APPLICATION NO.	FILING DATE	FIRST NAMED INVENTOR	ATTORNEY DOCKET NO.	CONFIRMATION NO.
10/554,228	10/25/2005	Jan Alfons Catharina Mewissen	NL 030476	7923

Office Action Summary

Detailed Action

Fig1

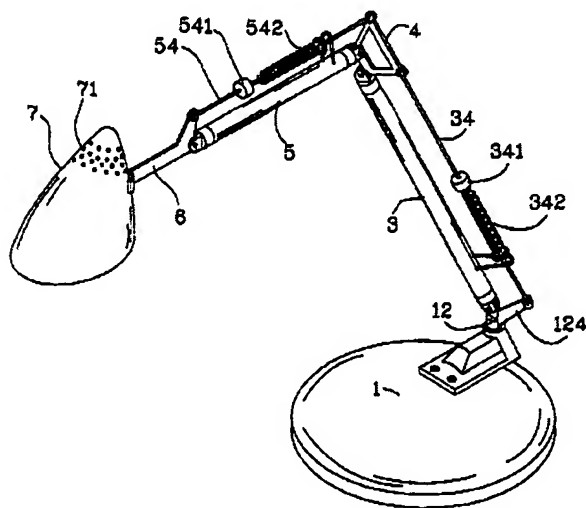
3. Regarding claim 1, Yang teaches a Lamp assembly (note Figure 1 below) having stand 1 (base), lower arm 3 (support) that is adjustable and pivotable to nearly any angular orientation (enclosing an angle α with the vertical axis) by swivel device 12. Lamp shade 7 (housing) containing a bulb and socket (radiation unit).

Yang further teaches that lamp shade 7 can be adjusted in the directions of the axes of X, Y and Z by turning the swivel device 12 on the axle holder 12 and, by pivoting the triple-terminal connecting frame 6 on the upper arm 5 and the upper wiring tube 54, the upper arm 5 and the upper wiring tube 54 on the lower arm 3 and the lower wiring tube 34, and the lower arm 3 and the lower wiring tube 34 on the swivel device 12 respectively. See column 1, line 55-68; column 2, line 1-52; and Figure 1 above.

Fig2

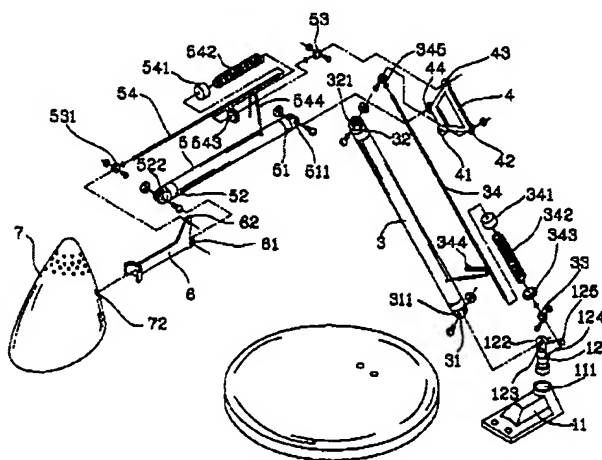
4. Regarding claim 2, Yang teaches the use of a retaining device (blocking system) connected to upper arm 5 and lower arm 3 for holding the lamp and shade in any fixed X,Y,Z position (Note Figure 2 below). The retaining device includes a stop loop 44 fastened to the upper arm 5 around the upper wiring tube 54, where spring coil 542 is sleeved on the upper wiring tube 54 and stopped between a fixed ring 541 and a movable ring 543 (cylindrical blocking elements) on the upper wiring tube 54 by the stop loop 544. Col. 2, line 39-44.

5. Regarding claim 4, Yang teaches the upper arm 5 (shaft) and the lower arm 3 (support) are pivotably connected to each other via trapezoidal open frame 4, wherein the upper arm 5 can pivot about the axis (a pivot axis) formed when forked connector 51 is connected to pinhole 44 on frame 4 (fastening element) using a screw and nut (a clamp element), and upper arm 5 is also pivotable about the axis formed when pinhole 44 on frame 4 is connected to forked connector 32 by a screw and nut. Col. 2, line 3-13; and Figure 2 above.

8. Regarding claim 3, Yang teaches the use of a triple-terminal connecting frame 6 that is pivotably connected (note Figure 2 above) at one end to the retaining device (blocking system), where the other end has a cup shaped protrusion that is fixed to the lamp shade 7 by screw holes 72. Col. 2, line 29-36.
